Re: Advanced Auto
10026 Central SE
Traffic Circulation Layout
Engineer's/Architect's Stamp dated 5-19-16 (L20-D056A)

DRAINAGE AND TRANSPORTATION INFORMATION SHEET (REV 09/2015)

Project Title: Advance Auto - 10026 Central Ave Building Permit #: _____ City Drainage #: L20D056A

1 SITE PLAN
C1 SCALE: 1" = 20'-0"

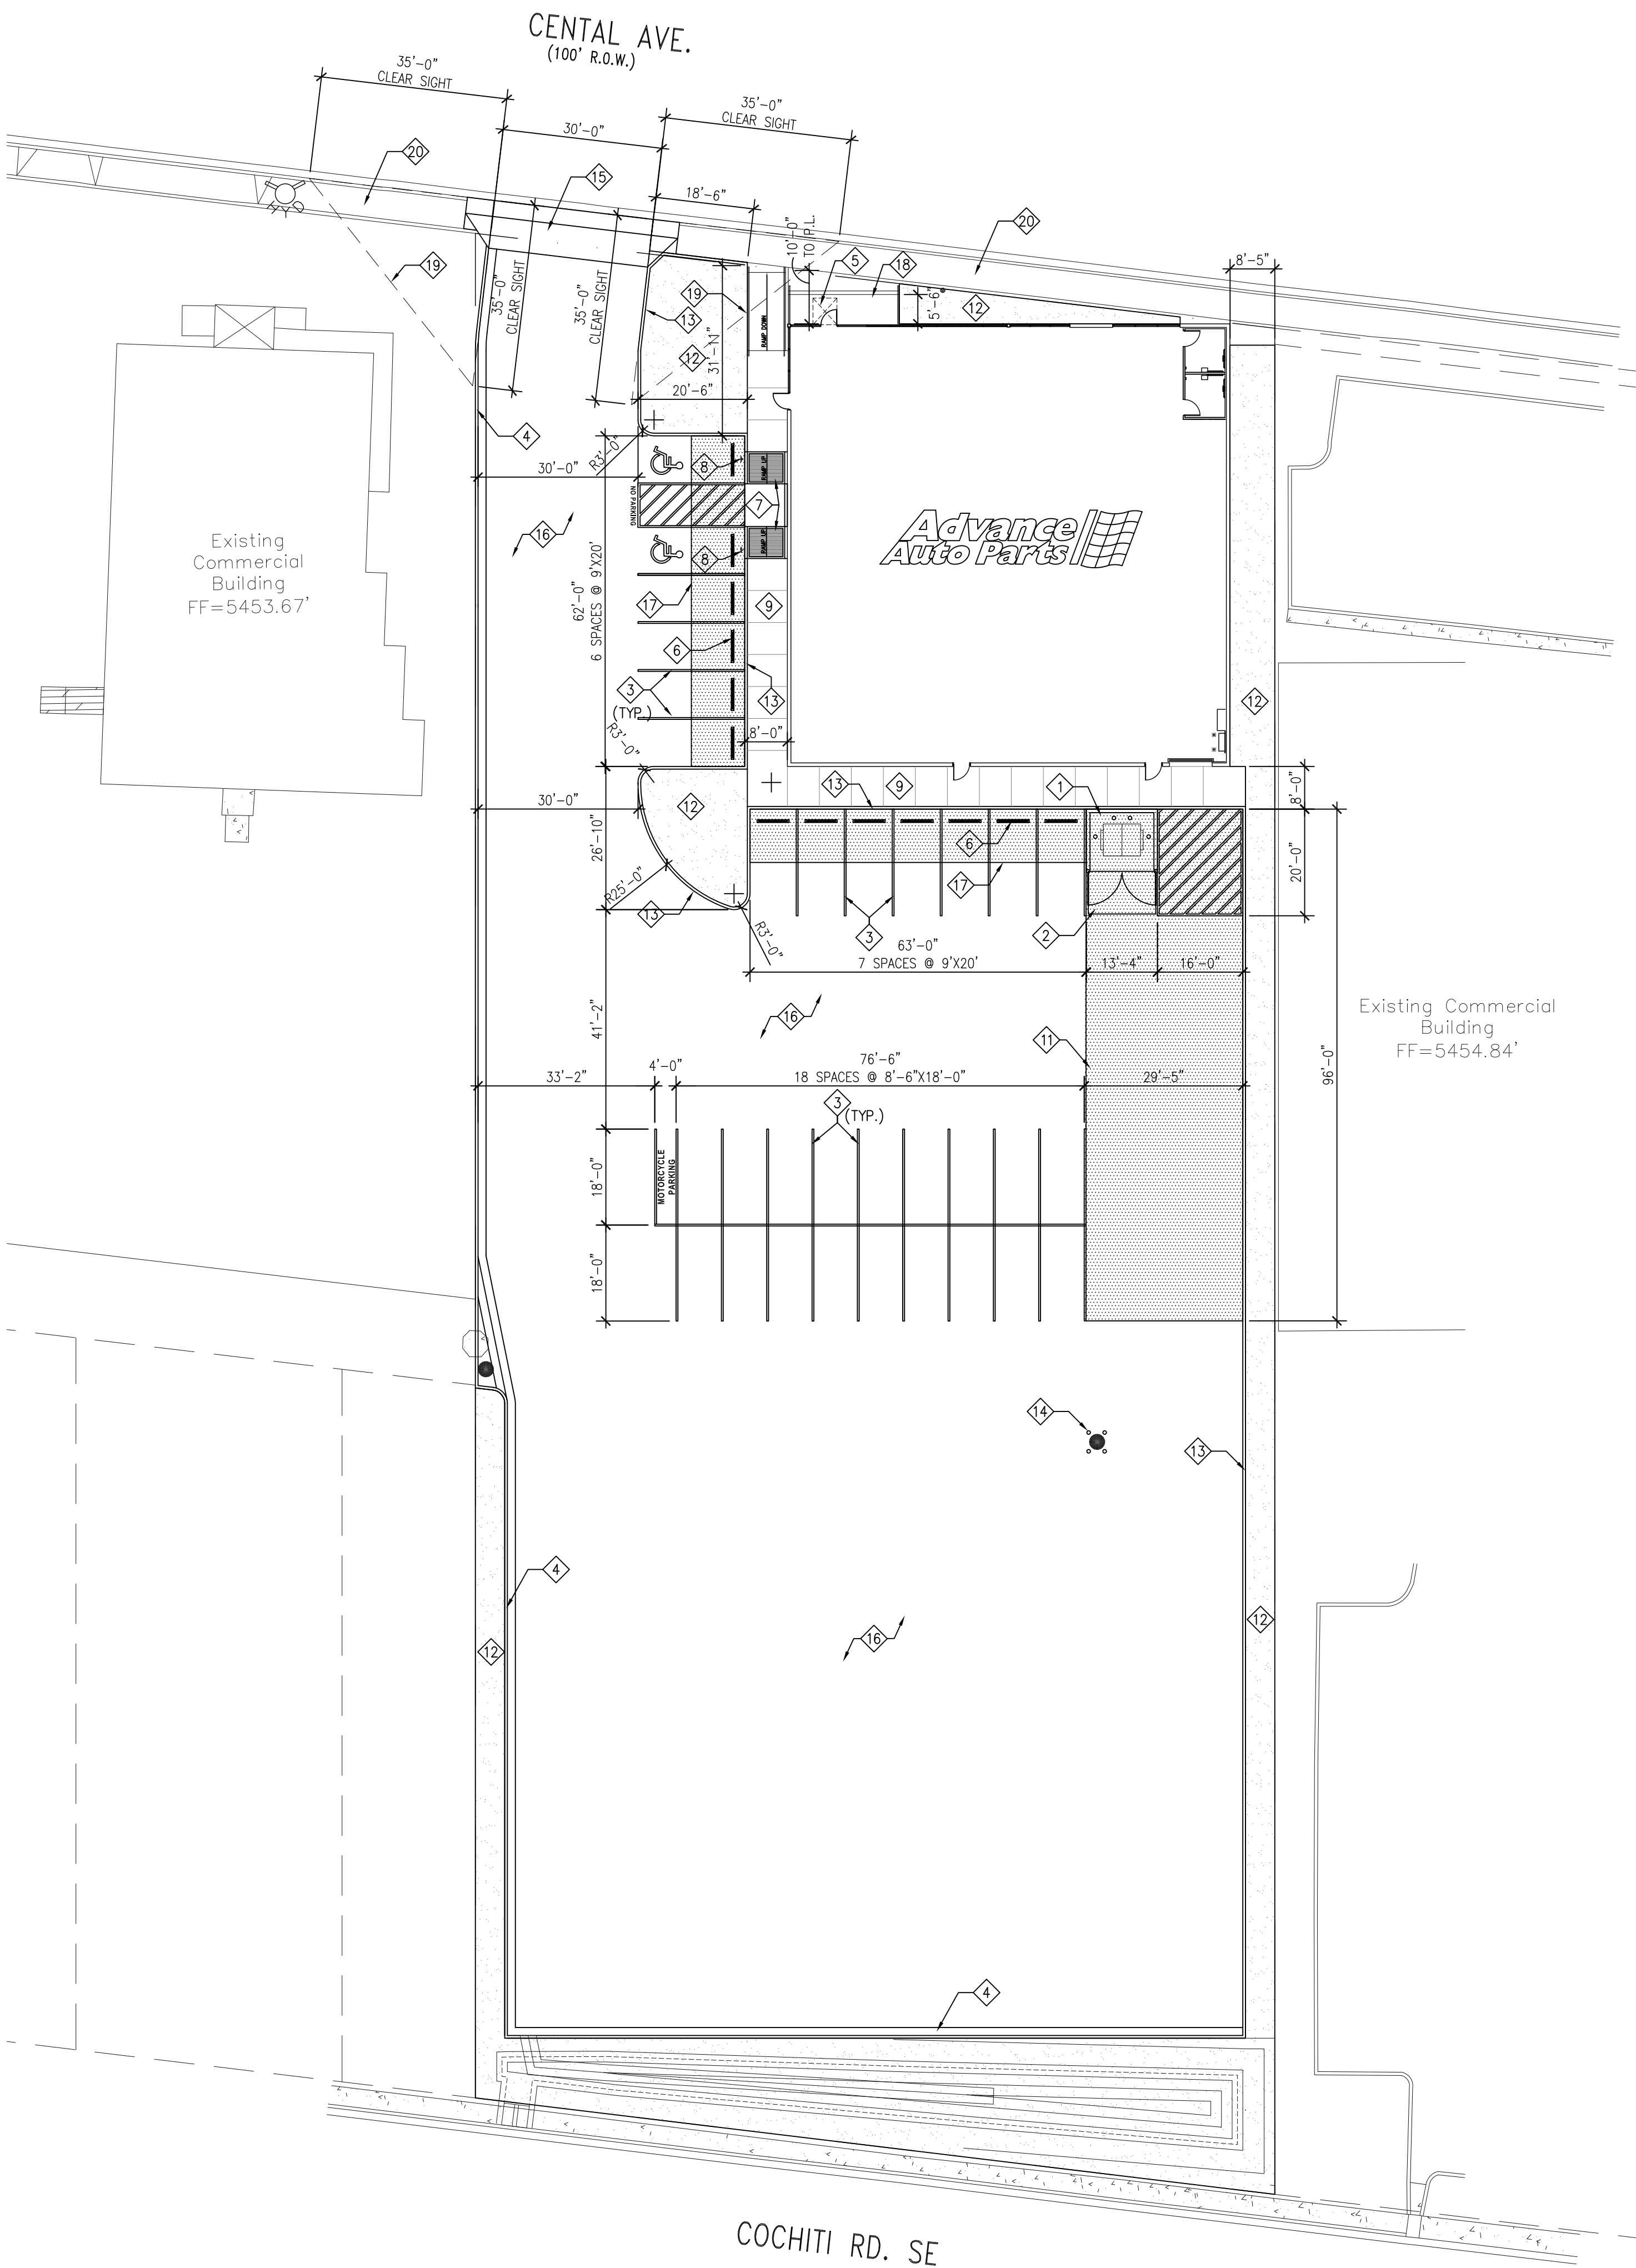
The TCL submittal received 6-23-16 is approved for Building Permit. A copy of the stamped and signed plan will be needed for each of the building permit plans. Please keep the original to be used for certification of the site for final C.O. for Transportation.
